TECHNICAL BULLETIN

## Software Glitch on GT20

Bulletin Number: 96

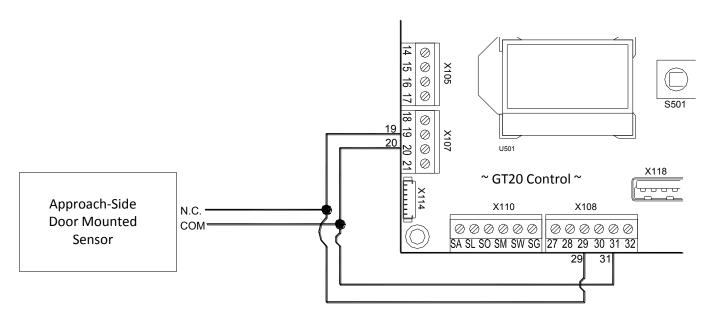
It has come to our attention that the GT20 has a software issue related to push side door mounted sensors.

If a door mounted sensor is installed on the push side of the door and the sensor is in detection, the door will not activate from either the sensor or another source such as a wall switch. Once sensor detection ceases, the door will open from an alternate activation. To our understanding this only pertains to the latest software release V01.02.20.

Refer to the illustration below. If you encounter this problem, the workaround is to parallel the lock output to the safety input by installing jumpers between terminals 19 & 20 and 29 & 31. This will resolve the problem until a new software update becomes available.

- 1. Under "config",
- 2. "Unlock" must be set to "Perman".
- 3. "LockAU, "LockEX", and "LockMA" must all be set to "Lock".

The above diagram uses the electric lock output to resolve the problem. If the lock output isn't available, then a door-position switch would be needed to provide a closed contact into terminals 19 and 20 when the door is closed.
